APPLICATION NO.	FILING DATE	FIRST NAMED INVENTOR	ATTORNEY DOCKET NO.	CONFIRMATION NO.
10/659,145	09/10/2003	Marie Ann McMasters	GE126465	3043

Office Action Summary

DETAILED ACTION

FIG. 3

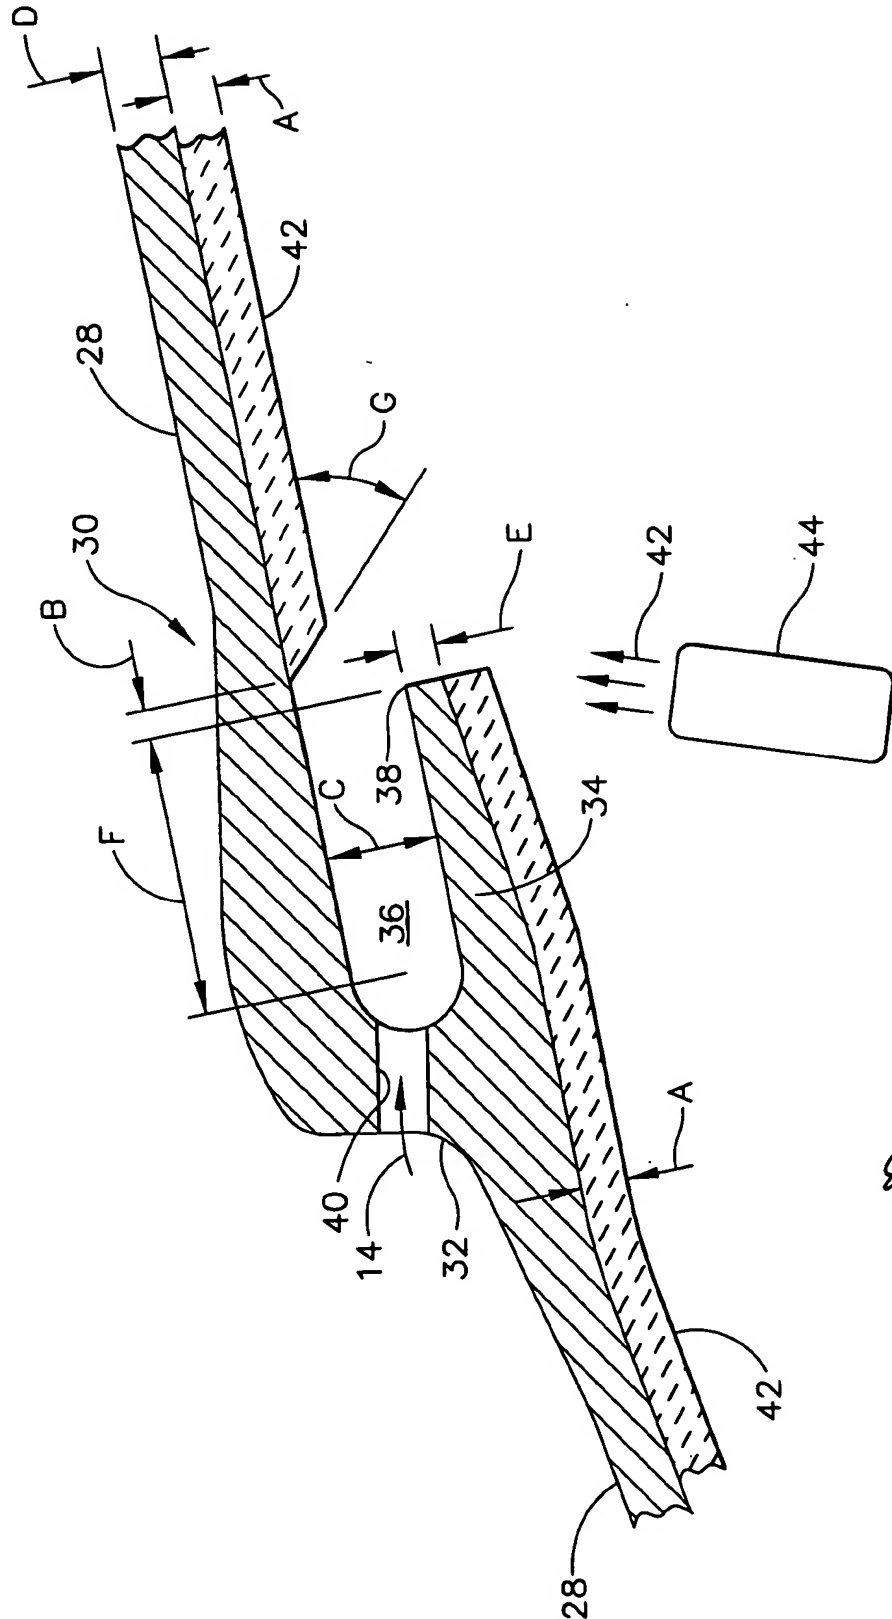
1. Claims 1-22 are rejected under 35 U.S.C. 112, first paragraph, as failing to comply with the written description requirement. The claim(s) contains subject matter which was not described in the specification in such a way as to reasonably convey to one skilled in the relevant art that the inventor(s), at the time the application was filed, had possession of the claimed invention. Applicant's amendment of the specification and drawings is inconsistent with those originally filed with the office. In the originally filed drawings in Figures 3 and 4, the "transverse" spacing B was shown diagonally to indicate the spacing between the lip and the coating aft of the slot. Originally filed Figure 4 shows the spacing H as an "axial spacing". Applicant's modification of the figures removes the original "B" from both Figures, replaces "H" in Figure 4 with "B", and uses an "axial spacing" B in both Figures 3 and 4. However, it is clear from the specification that spacing C was also "radial" or "transverse" and applicant cannot designate spacing B, which was originally designated as a "transverse spacing" in paragraphs 31-34 and yet with the amendment to paragraph 50 changes the designated spacing B to an "axial spacing." Applicant's amendment introduces new matter in redefining how the spacing B, which is the only spacing generic to both Figures 3 and 4, from that of the original specification and drawings.

Entry Not
 Approved
 Issue of
 new matter
 TN
 5/5/05
